## CITY OF ALBUQUERQUE

Re: 1623 - Townhouse

**Traffic Circulation Layout**

The TCL submittal received 4-17-2019 is approved for Building Permit with. A copy of the stamped and signed plan will be needed for each of the building permit plans. Please keep the original to be used for certification of the site for final C.O. for Transportation.

Sheet: Traffic Circulation Layout

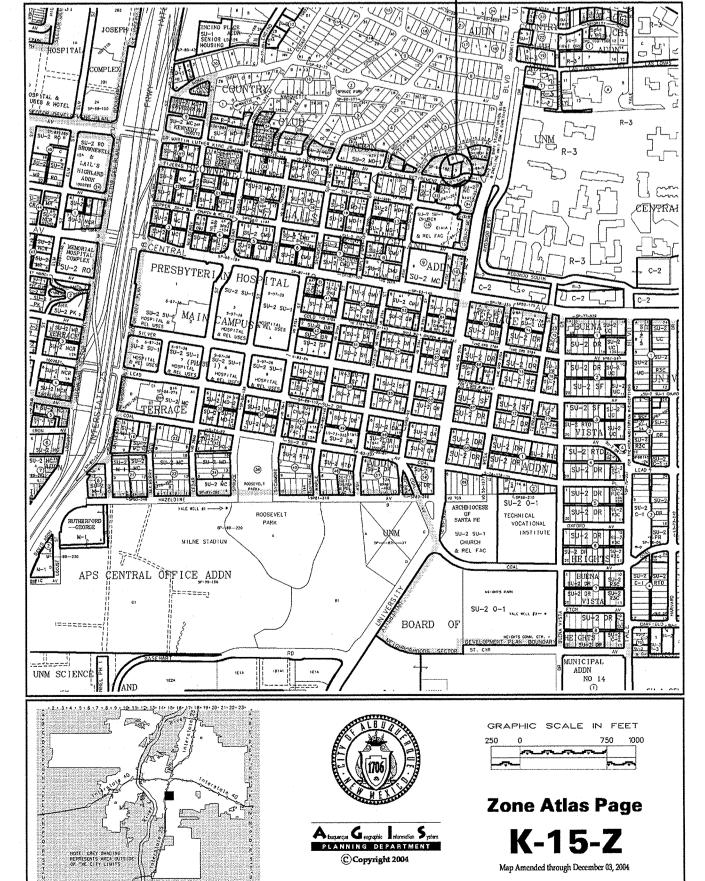
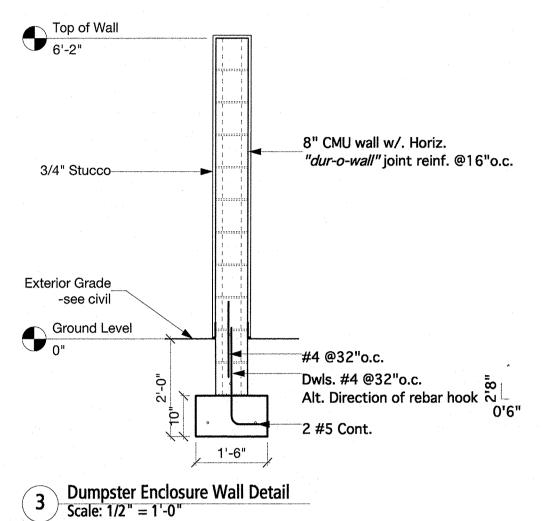
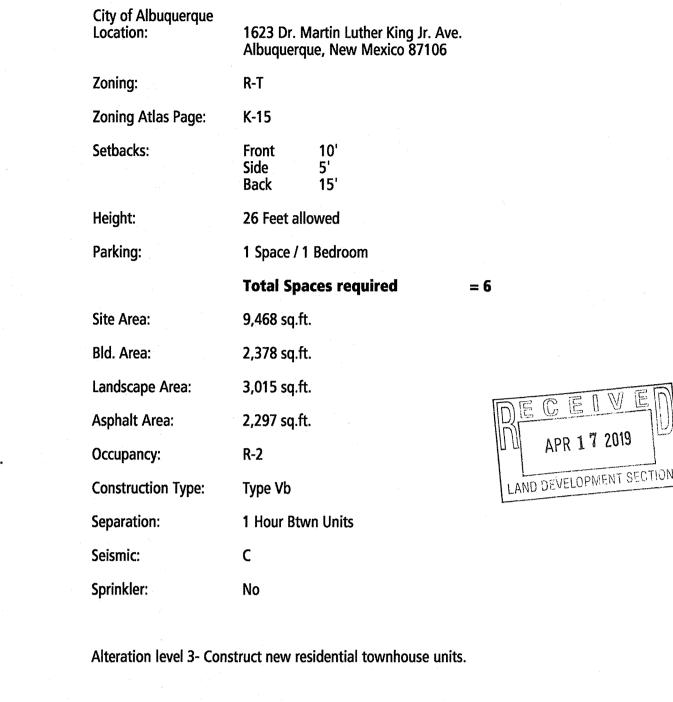
When the site construction is completed and a Certificate of Occupancy (C.O.) is requested, use the original City stamped approved TCL for certification. Redline any minor changes and adjustments that were made in the field. A NM registered architect or engineer must stamp, sign, and date the certification TCL along with indicating that the development was built in "substantial compliance" with the TCL. Submit this certification TCL with a completed <u>Drainage and Transportation Information Sheet</u> to front counter personnel for log in and evaluation by Transportation.
